Lake Lothing Third Crossing DCO

Submission at Deadline 7 on behalf of
Northumbrian Water Limited

15 March 2019

Figure 1 – 2022 Do Something sensitivity test

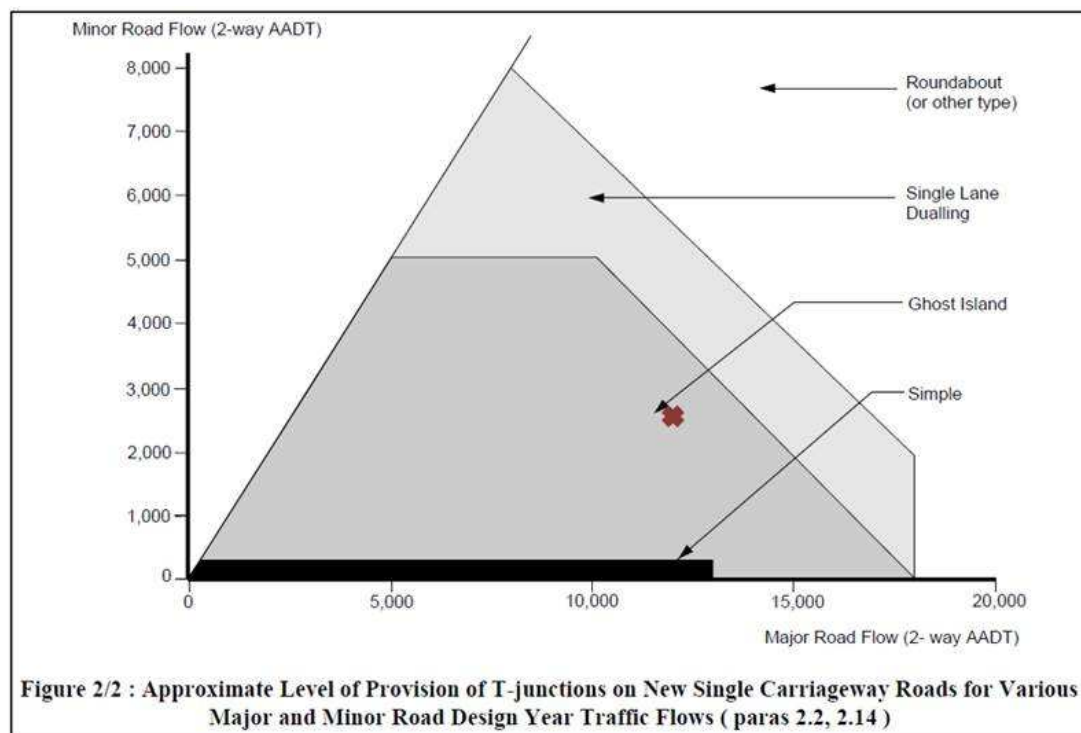
Major Road flows (Waveney Drive) – 11,700 AADT in 2022 (14,267 from ES less 2,600 on minor arm)
Minor Road flows (New Access Road) – 2,600 AADT in 2022 estimated using ATC factor data

- i) **2022 Opening Year** – Figure 2/2 shows the approximate level of provision of T junction lies within the 'Ghost island' section (i.e. what is currently proposed). The reported junction capacity assessments for 2022 also show the junction performing satisfactorily in the opening year in the sensitivity test with extra traffic flows applied. The junction capacity assessment results are dependent on SCC clarifying the three points PBA have outlined above (including HGV %s, reduced visibility splays, and turning movement proportions). Even with these changes sought, PBA believe the junction form/design in the opening year is likely to be shown to operate within capacity.

Figure 2 – 2037 Do Something sensitivity test

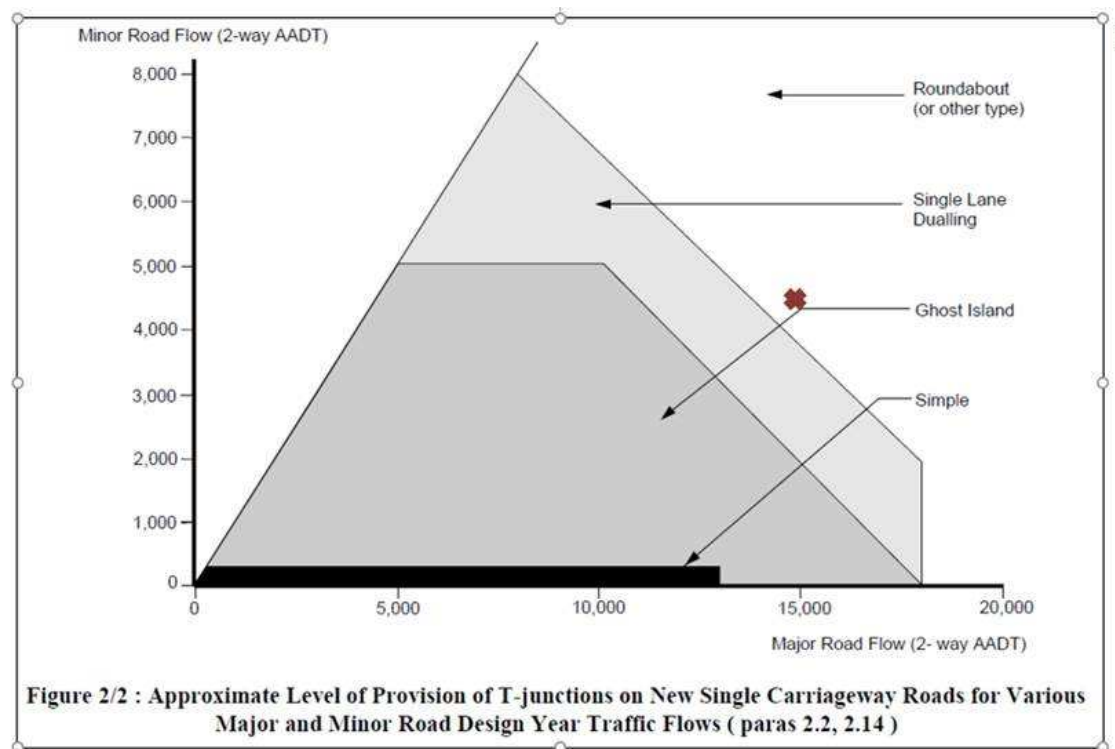
Major Road flows (Waveney Drive) – 14,280 AADT in 2037 (est. from model flows factored by 6)
Minor Road flows (New Access Road) – 4,420 AADT in 2037 estimated using ATC factor data

- ii) **2037 Future Year** – Figure 2/2 shows the approximate level of provision of T junction lies within the 'Roundabout (or other type)' section, and lies far from the 'Ghost Island' section. With this sensitivity test, this demonstrates that a ghost island T junction may not be the most appropriate junction form for the future forecast traffic flows (in this 2037 sensitivity test scenario, the minor road flow has increased, but PBA has estimated that the major road flow on Waveney Drive would decrease from the previous assessment since growth has occurred on the minor arm).

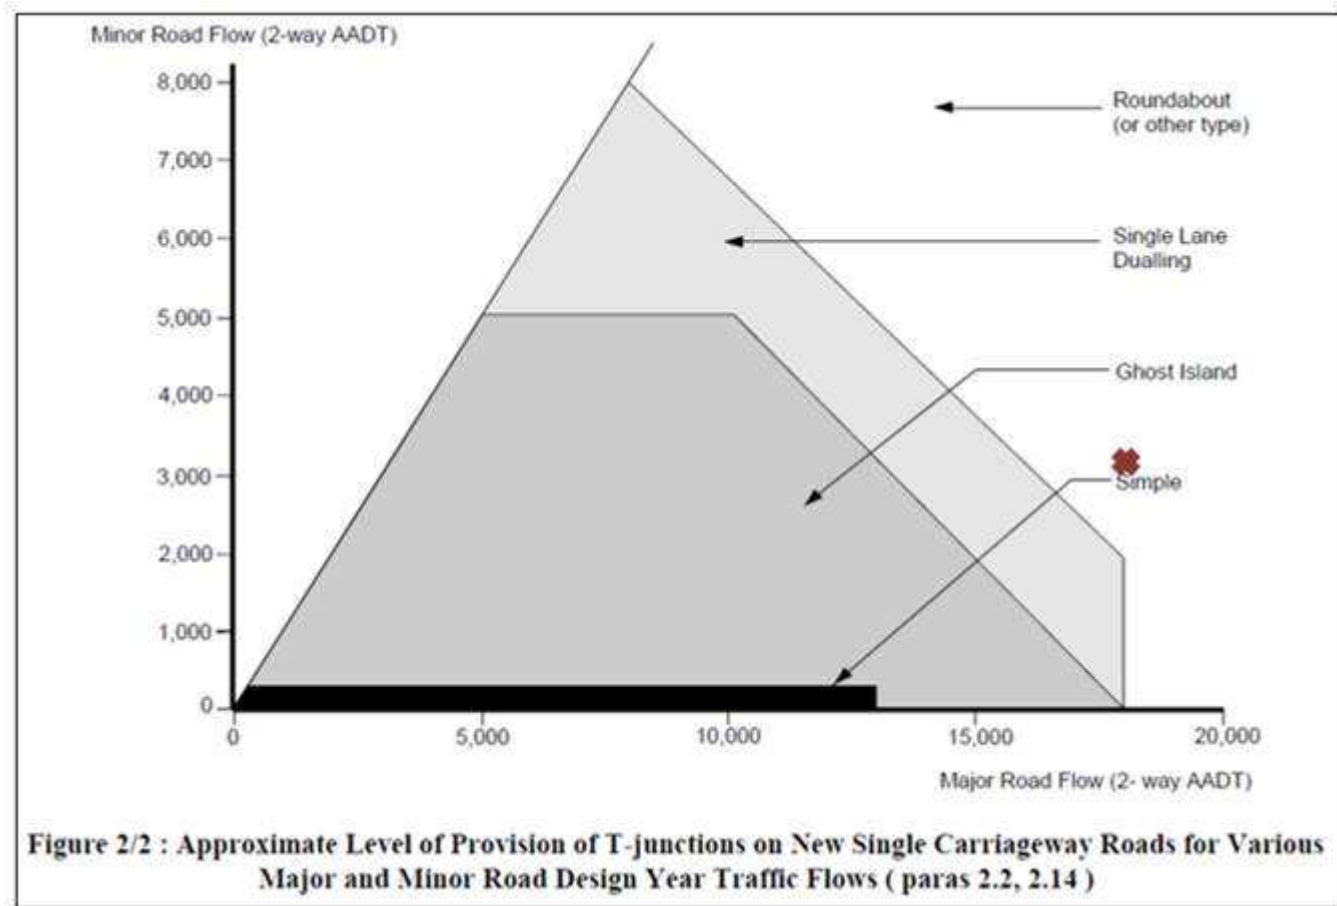
In accordance with the PICADY User Guide, the visibility distances for the minor road are measured from points 10m back from the give-way line. PBA would agree with the 'x' distance of 10m applied. However, in accordance with TD 42/95, the visibility requirements for a road subject to a 30mph speed limit is likely to be 4.5m x 90m. This visibility splay is what the junction and positioned highway boundary will be designed to, not the PICADY visibility measurements. In accordance with TD 42/95, providing too much visibility can be detrimental to highway safety.

PBA would need sight of a design drawing illustrating the TD 42/95 visibility splays and proposed location of the highway boundary to confirm if this level of visibility in the PICADY model is achievable and acceptable. PBA consider the visibility splays in the PICADY model are generous and would result in significant grass verge frontage. PBA would consider PICADY visibility splays for this junction to be around 10m x 50m. We would be grateful for clarification on this.
